ITEM	Page
LTC0520 Item 5 Edinburgh Road, Marrickville – Marrickville Metro Expansion Works - Traffic Changes (Midjuburi – Marrickville Ward / Newtown and Summer Hill Electorates / Inner West PAC)	3

Subject: Edinburgh Road, Marrickville – Marrickville Metro Expansion Works - Traffic Changes (Midjuburi – Marrickville Ward / Newtown and Summer Hill Electorates / Inner West PAC)

Marrickville Metro – Edinburgh Road Right Turn

Road Safety Audit

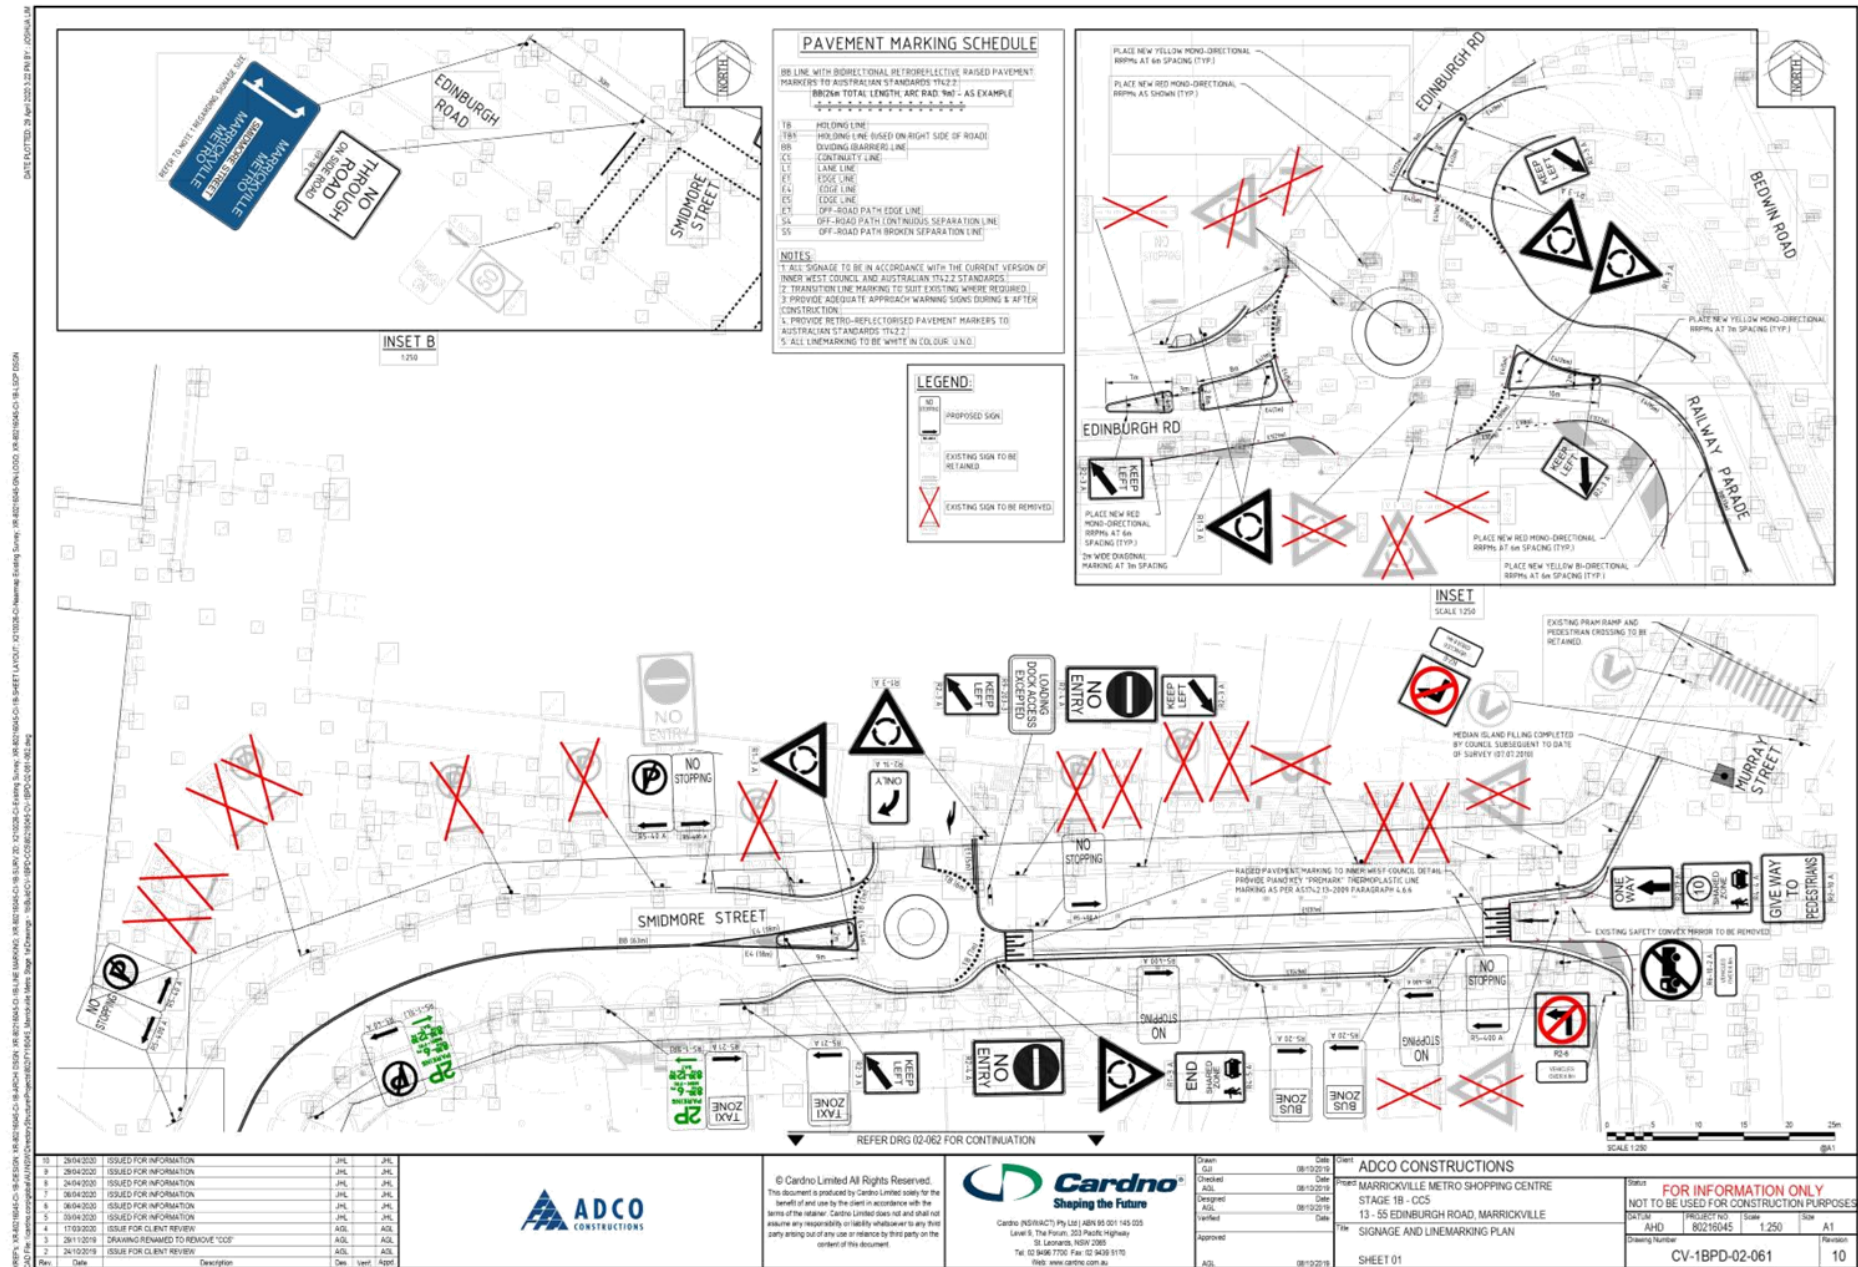
- a) The proposed 60.2m 'Bus Zone' (plan CV-1BPD-02-062) on north side of Edinburgh Road (between Sydney Steel Street and Murray Street) be reduced to 56m;
- b) The 'No Stopping' restriction for the departure side of proposed refuge/splitter island on Edinburgh Road (located east of Sydney Steel Street) be increased from 6.4m to 10.4m to comply with pedestrian refuge standards; and
- c) The existing bus stop, shelter and supporting infrastructure on the southern side of Edinburgh Road (immediately east of Sydney Steel Road) be relocated at the applicants cost and to Council satisfaction.

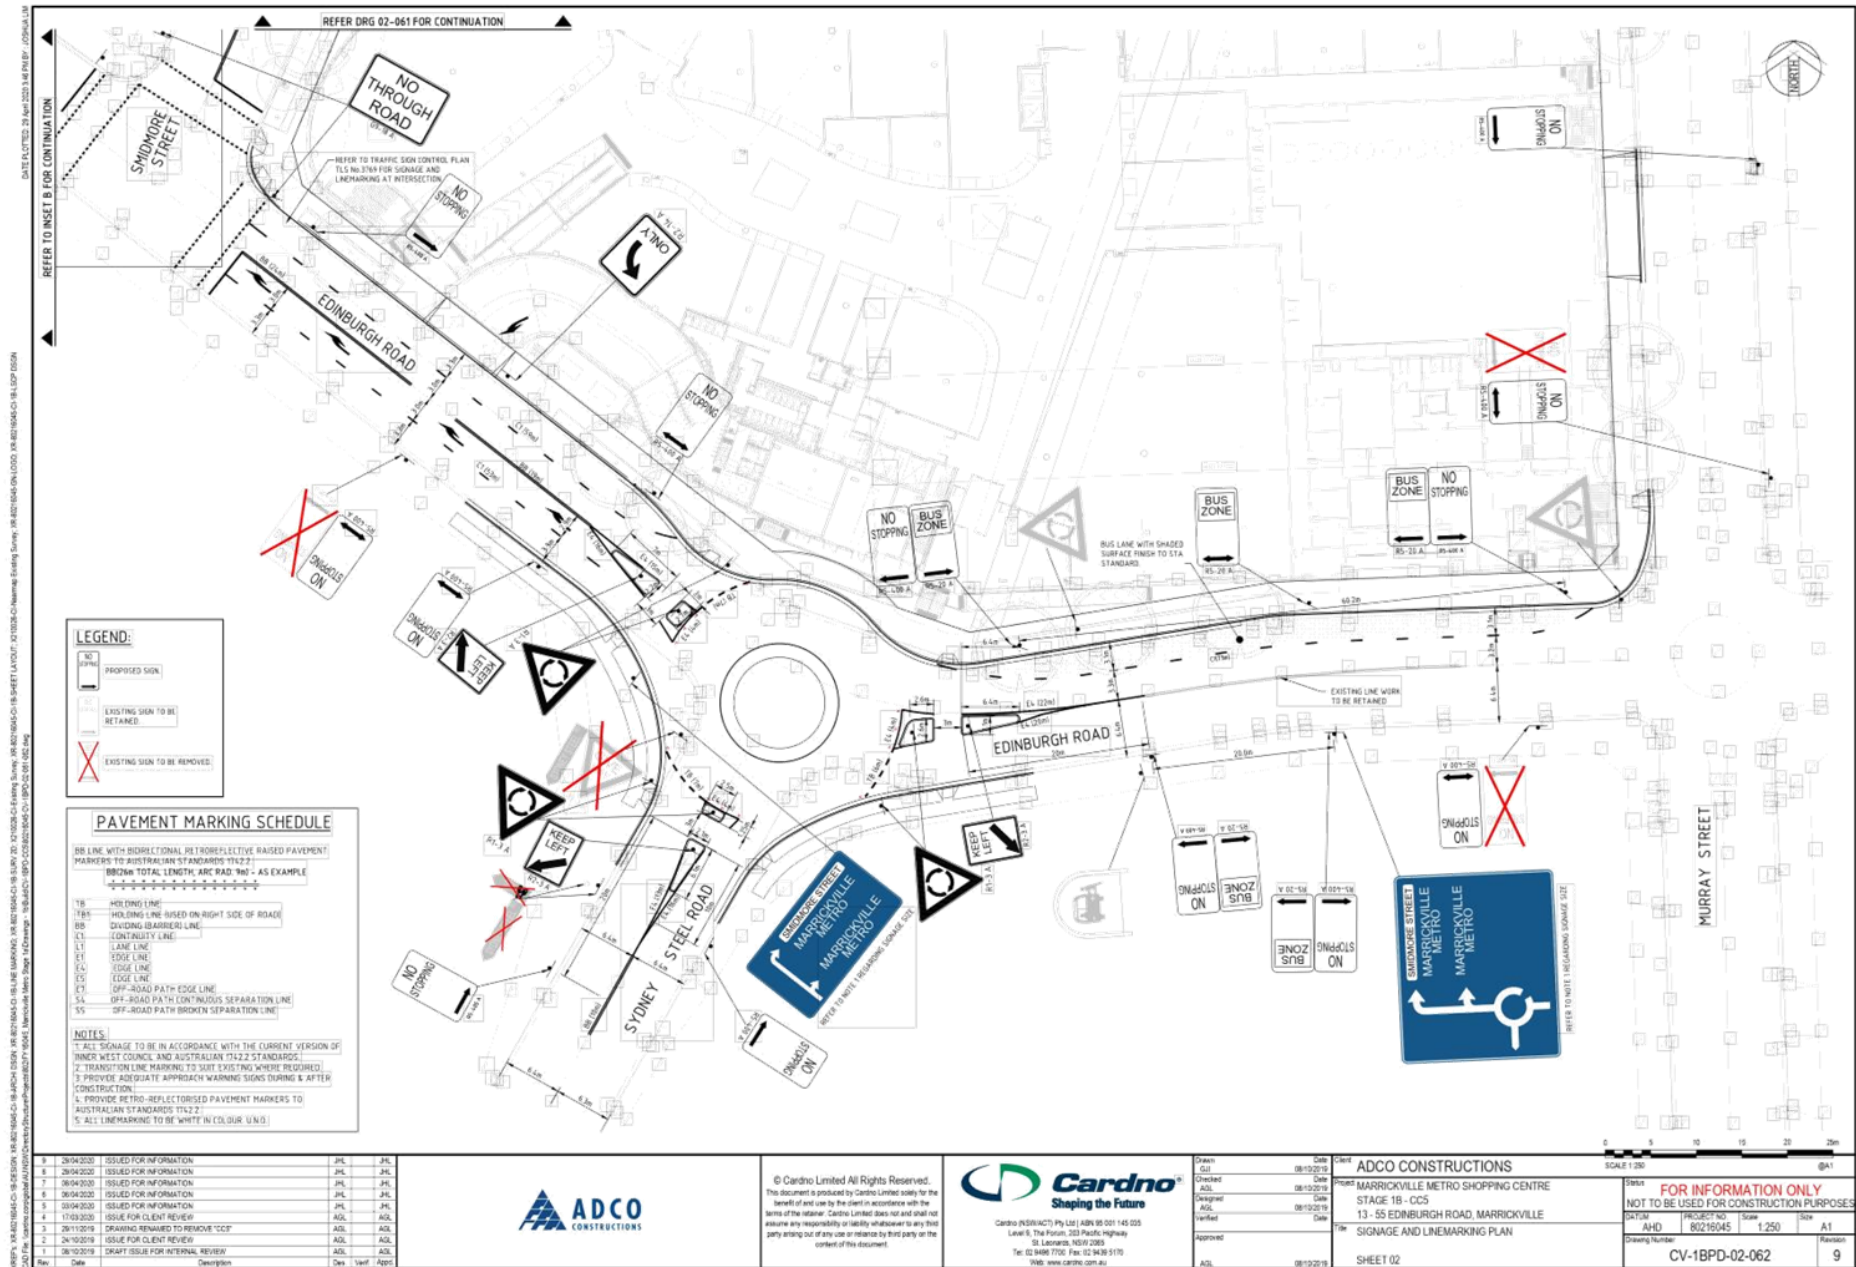
- The existing Bus Stop and shelter on the eastern side of Edinburgh Road (immediately east of Sydney Steel Road) will need to be relocated from its current location so that it does not conflict with the proposed 'No Stopping' restriction for the pedestrian refuge. This will result in the relocation of the existing bus stop and shelter by approximately 12-15m and will result in the loss of two unrestricted on-street car parking spaces being lost.

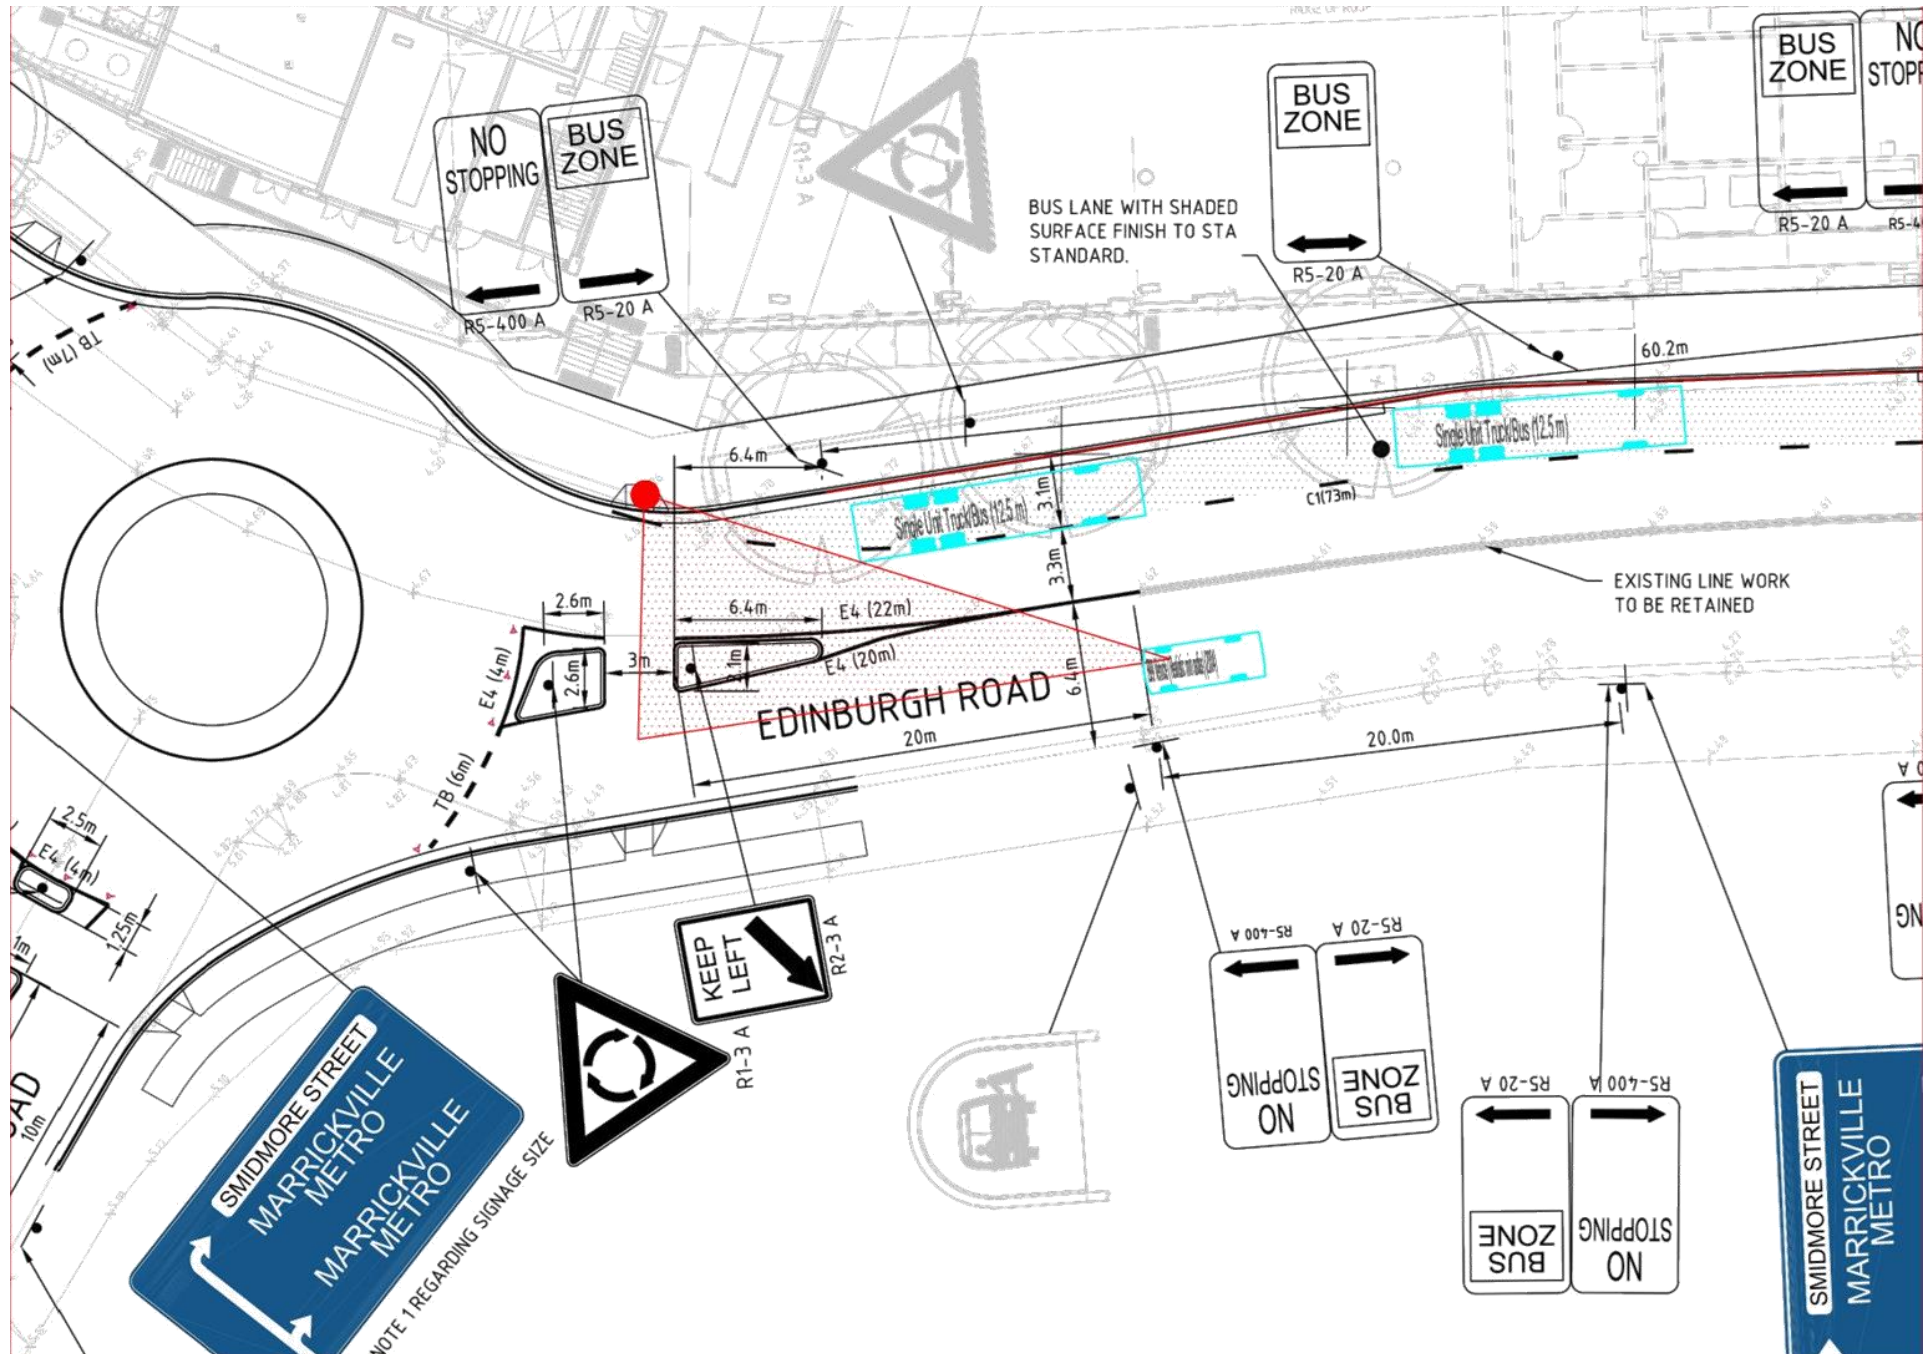
- Provision of a bus terminus on the northern side of Edinburgh Road between Sydney Steel Street and Murray Street (to accommodate up to 3 buses). The length of the bus zone will be approximately 56m in length and will commence at least 10m east of the proposed refuge/splitter island located on the eastern leg of the proposed roundabout. Although not shown on the provided plan, this will form a condition of approval. The pedestrian refuge requirements are met.
